**MAIN OFFICE RENOVATIONS
BERKS COUNTY INTERMEDIATE UNIT**

**MAIN OFFICE RENOVATIONS
BERKS COUNTY INTERMEDIATE UNIT****GENERAL CLARIFICATIONS**

1.10 The following attached Sketches and Drawings dated 10.27.25 are hereby issued with this Addendum:

1.15 Drawing A-4 – Demolition Plan First Floor – Unit A

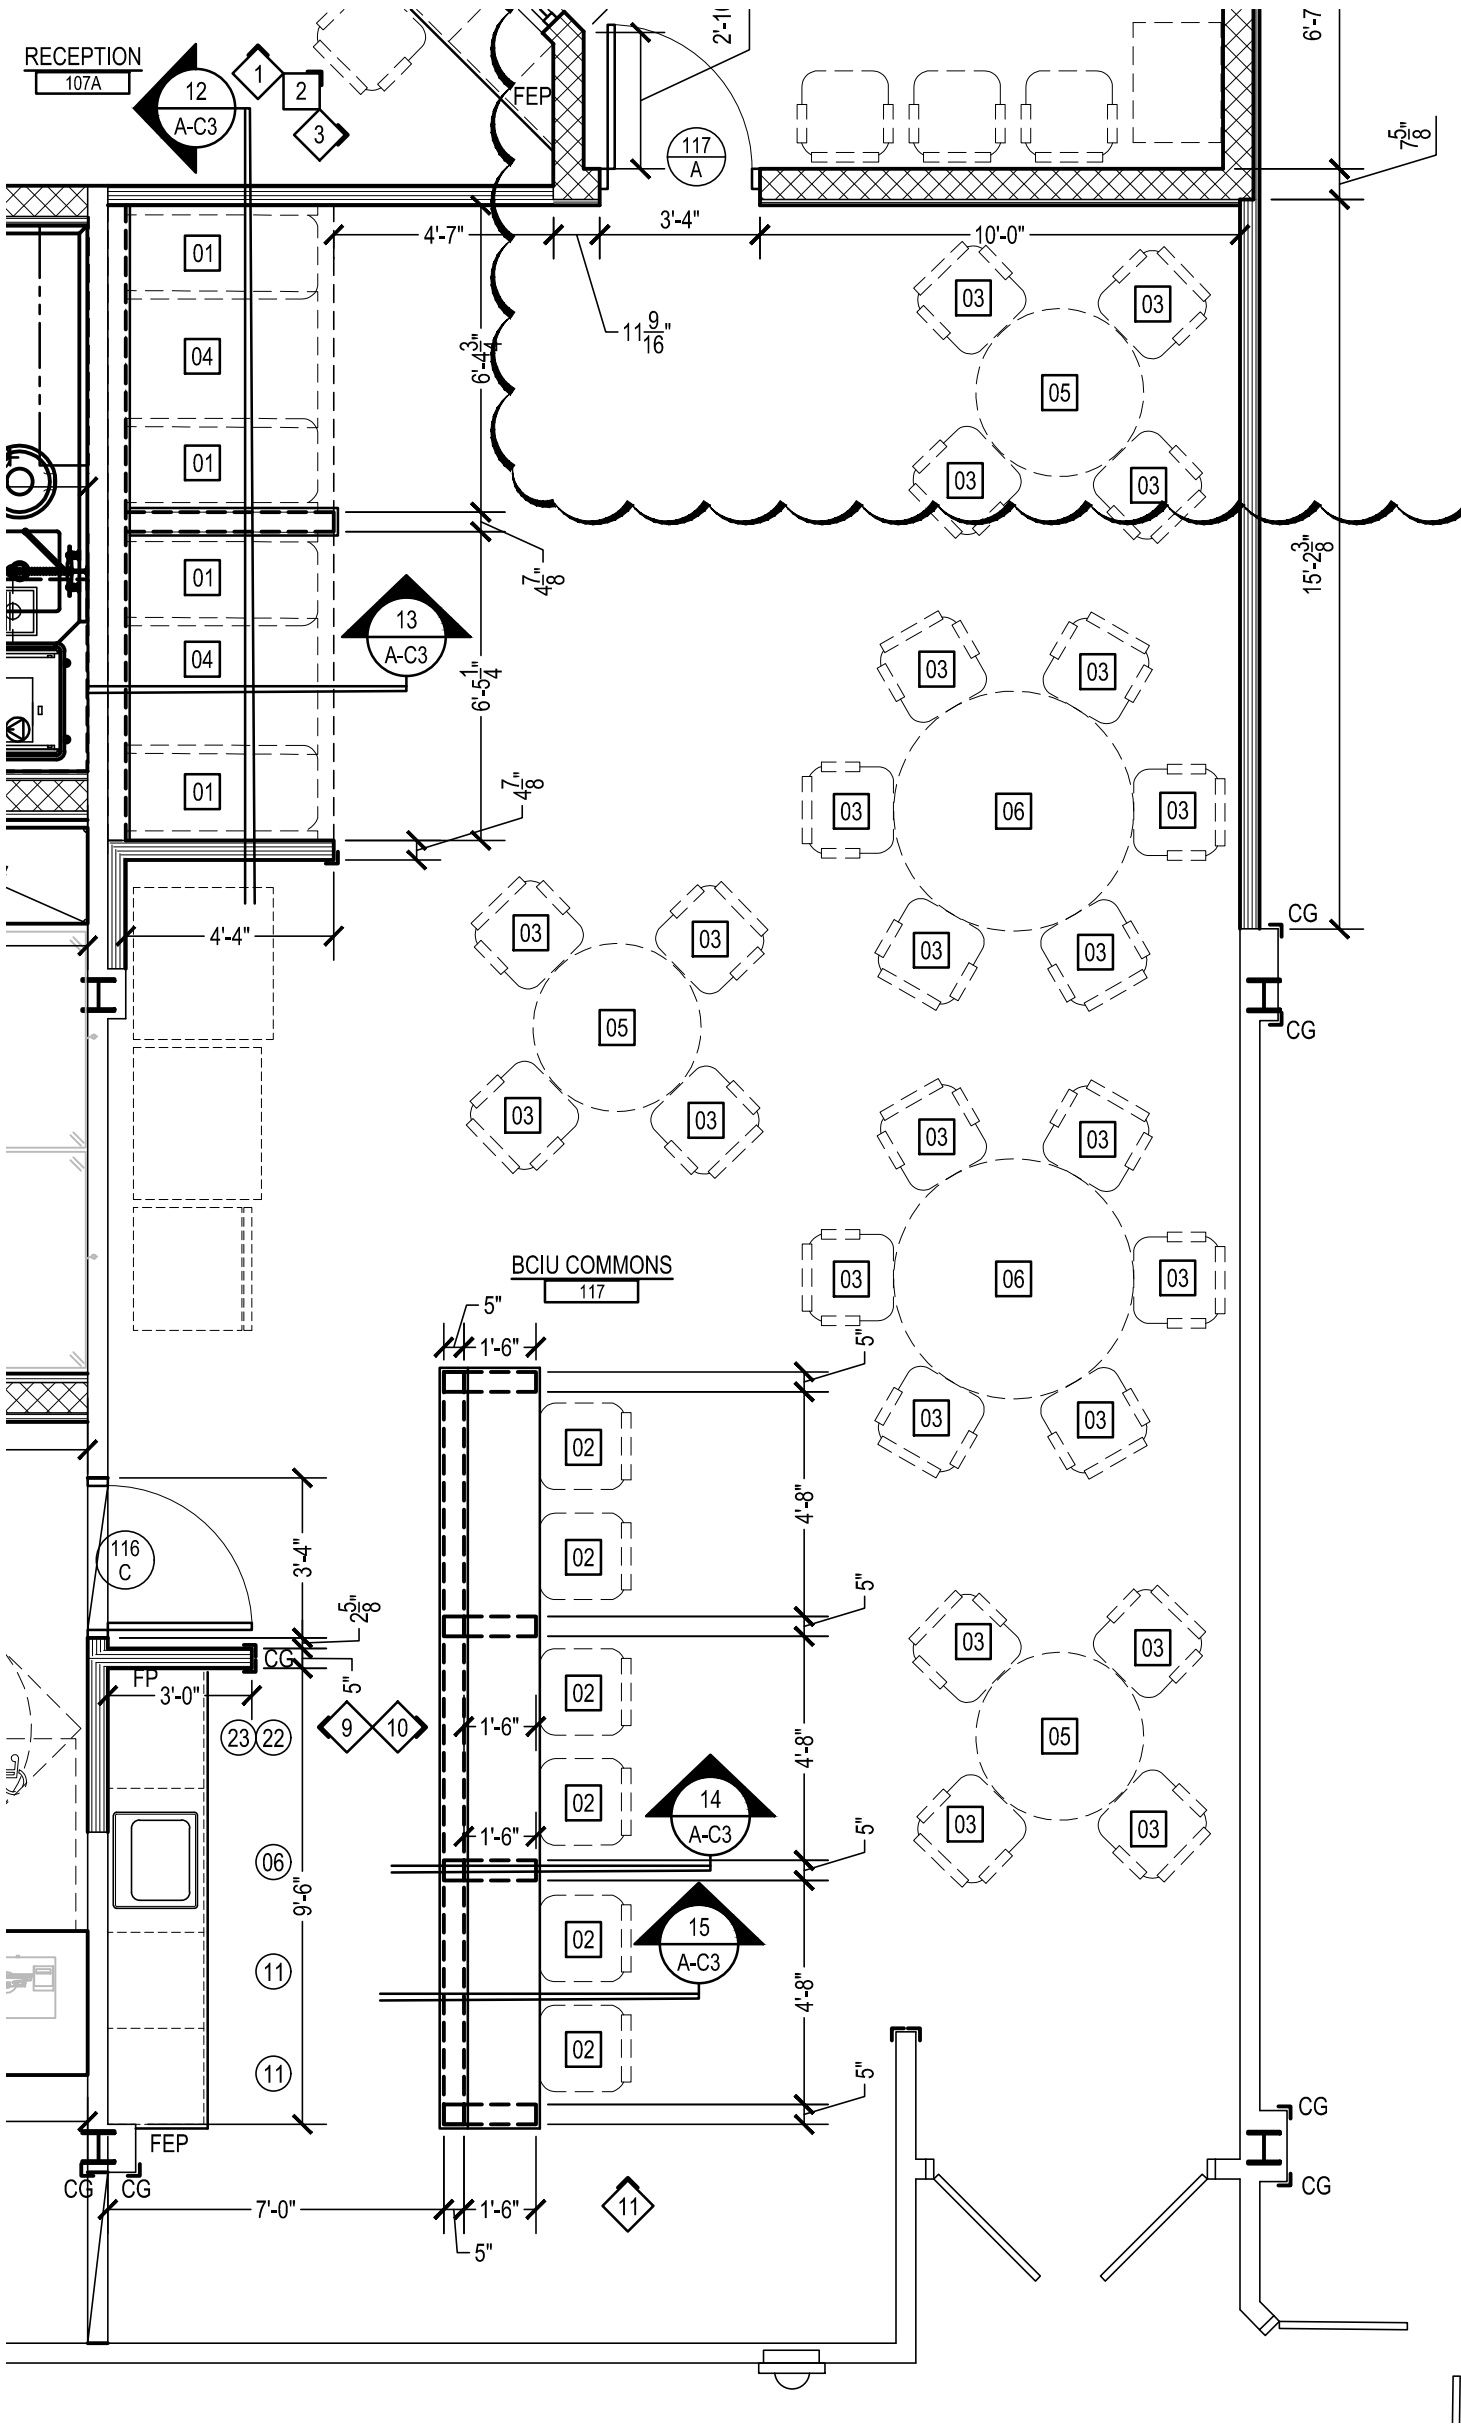
- A. In Board Room 127, remove Note 10G from the left side of the space.

ALTERNATE #130

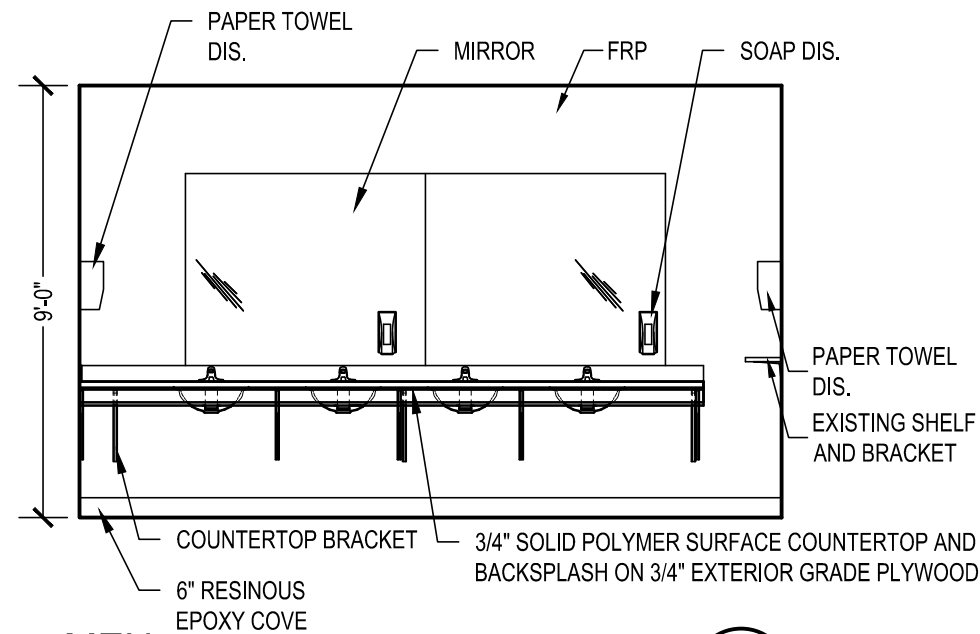
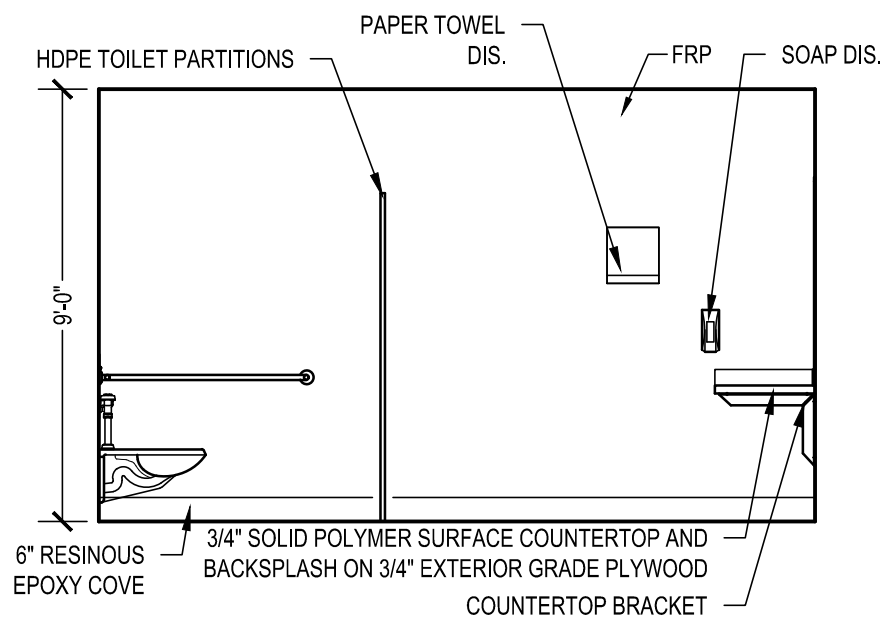
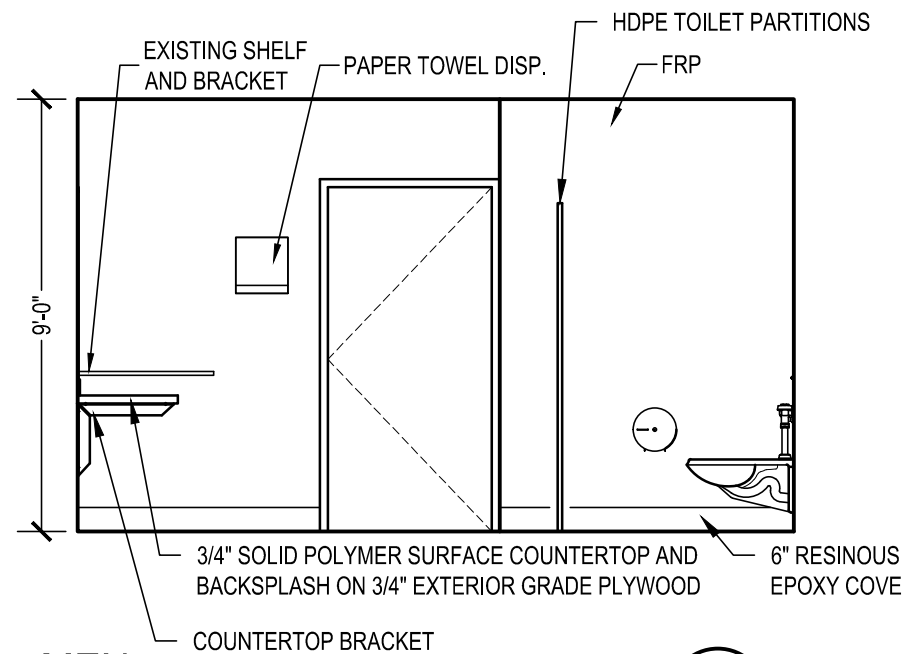
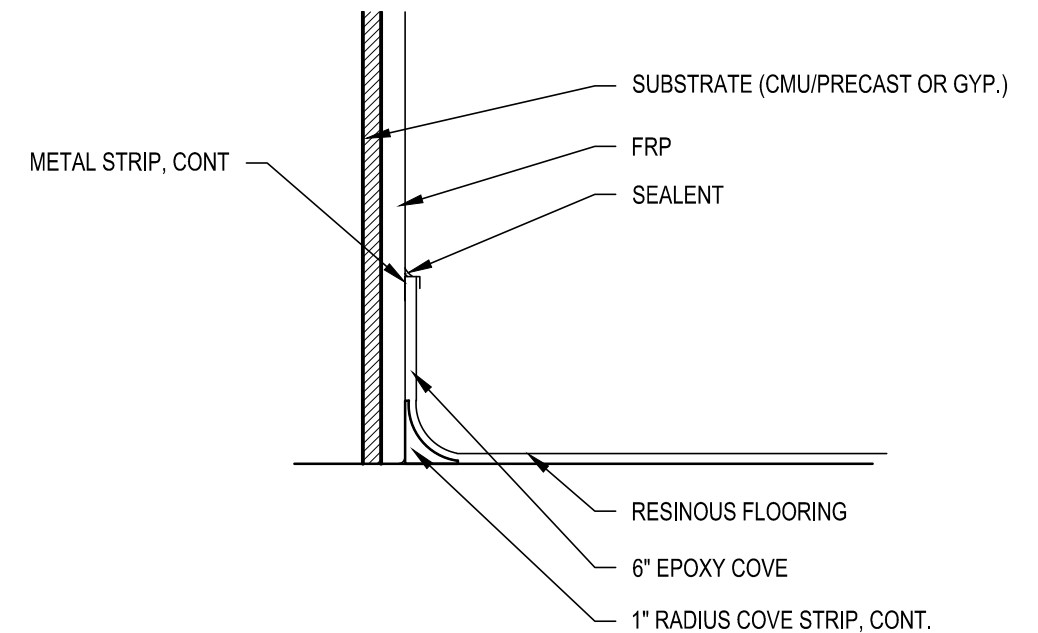
- NOTE:
1. REMOVE AND PROTECT ALL TOILET ACCESSORIES FOR REINSTALLATION.
 2. PROVIDE NEW 48 x 60 MIRRORS TO MATCH EXISTING.

EXTERIOR SIGN ATTACHMENT DETAIL

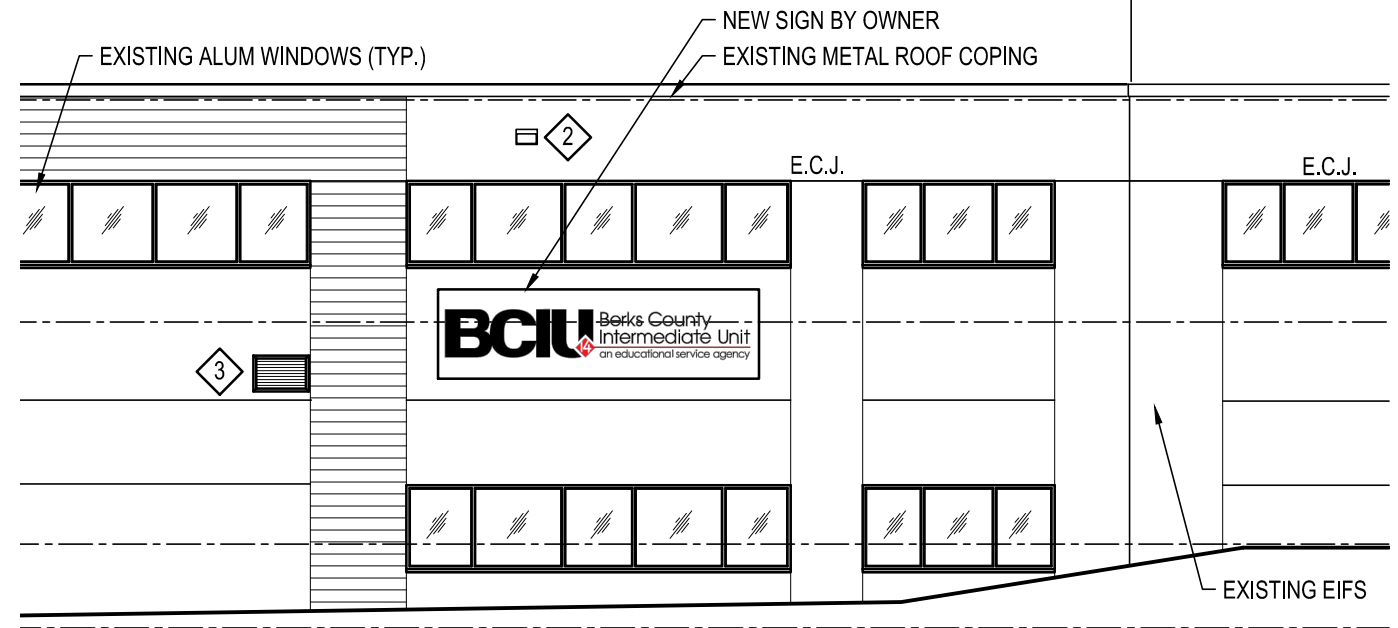
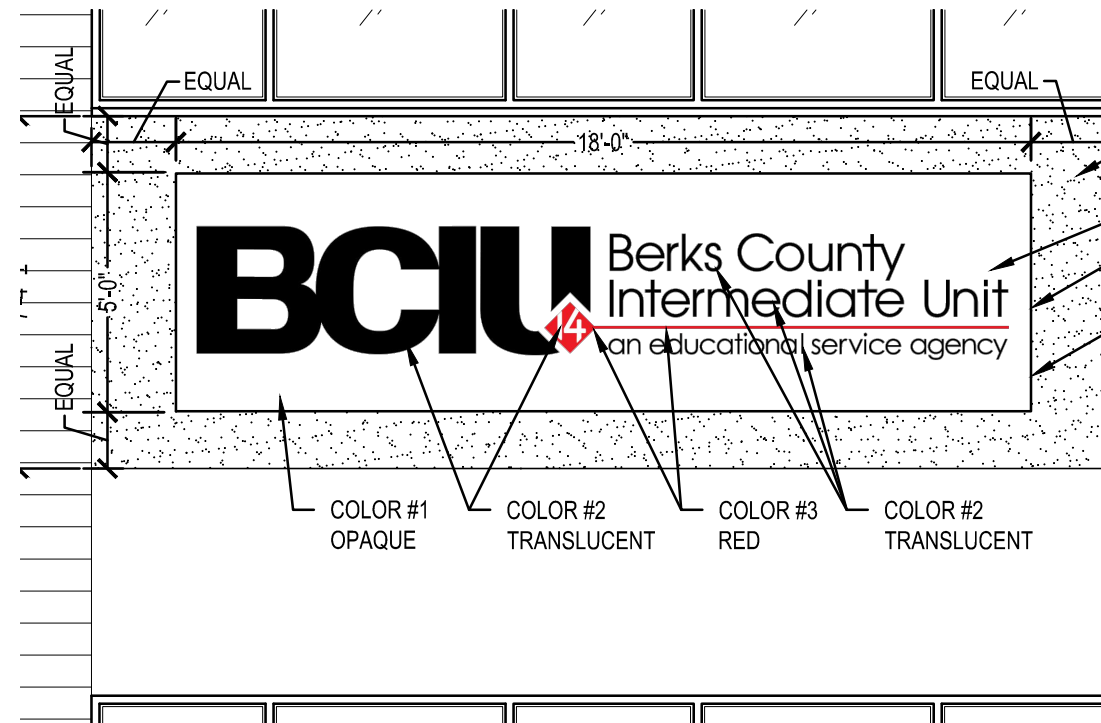
- EXISTING WALL CONSTRUCTION
- NEW EXTERIOR GRADE GYP. BD. SHEATHING TO MATCH EXISTING (EQUAL TO USG SECURROCK)
- NEW EIFS TO MATCH EXISTING
- MANUFACTURES STANDARD FLASHING
- CONTINUOUS 1/8" ALUMINUM STIFFENER PLATE. WELDED TO FACE FOR FASTENING THROUGH HOUSING
- 1/8" ALUMINUM SIGN HOUSING. FULLY WELDED WITH POLYURETHANE PAINT FINISH ON ALL SURFACES (WHITE INTERIOR)
- 12V / .9W LED LIGHT MODULES WITH 5" MAX. COVERAGE SPREAD
- 3/4" CLEAR PLEXIGLASS SHEET ROUTED TO CREATE 1/2" PROJECTION FROM FACE OF SIGN
- "3M" TRANSLUCENT VINYL APPLIED TO FIRST SURFACE OF PLEXIGLASS
- 1/8" ALUMINUM SIGN HOUSING. FULLY WELDED WITH POLYURETHANE PAINT FINISH ON ALL SURFACES (WHITE INTERIOR)
- 1/8" ALUMINUM REMOVABLE SIGN FACE WITH POLYURETHANE PAINT FINISH

- 2x BLOCKING PER SIGN MANUFACTURE REQUIREMENT
- THREADED STUDS WELDED TO BACK OF SIGN FACE FOR FASTENING PLEXIGLASS
- MANUFACTURES STANDARD FLASHING

- PROVIDE NEW EIFS IN THIS ENTIRE AREA TO MATCH EXISTING
- NEW SIGN DESIGN BY OWNER
- CONTINUOUS SEALANT ALONG ALL VERTICAL SURFACES
- DEMO EXISTING BUILDING LETTERS AND EFIS TO SUBSTRAIGHT
